Our Ref: P24-0782
Your Ref: -
Direct Dial: [REDACTED]
Email: [REDACTED]
Date: 28 May 2025

RE: 25/00104/FP – Residential development to provide nine flats with associated vehicular parking and access via existing dropped kerb from King James Way with ancillary bike and refuse store - Land to the Rear of Banyers Hotel King James Way Royston Hertfordshire SG8 7BZ

Extract from [Map – Flood map for planning – GOV.UK](https://www.gov.uk/government/uploads/system/uploads/attachment_data/file/362812/Map_-_Flood_map_for_planning_-_GOV.UK)

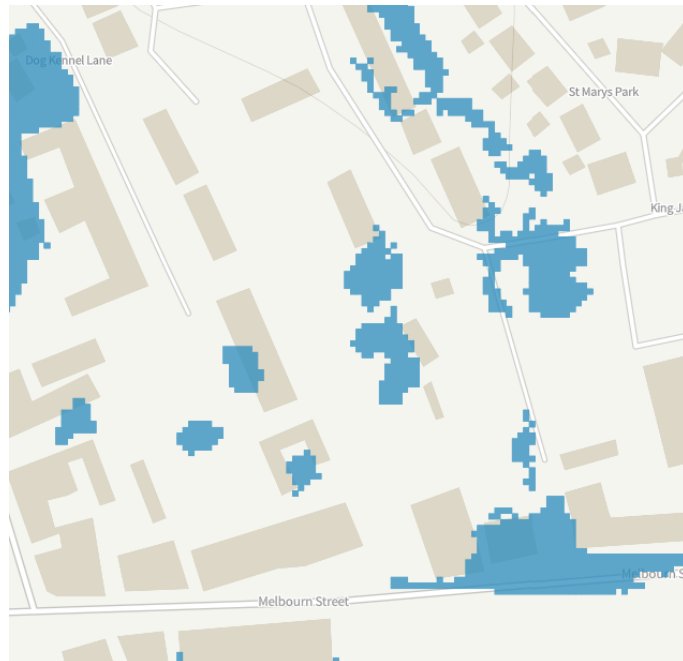
1. *A sequential test is required to be conducted for the site as majority of the site is in a surface water flow path with high risk of flooding.*

As outlined in the Design Validation Report, the following proposed design solution has evolved from the previous planning approved design and Flood Risk Assessment facilitated by ENCON Associates, reference A5992, in which the report confirms the site continues to reside within Flood Zone 01, with 1 in 100 year surface water flood risks occurring to the eastern margin of the site, which has been defined in the design as landscaping.

To that end and with the provision of elevated thresholds to the apartments, positioned outside of the flood profile to mitigate the risk of flood pathways, the associated allocation of residential development within the centre of the existing development footprint, is proposed to be acceptable.
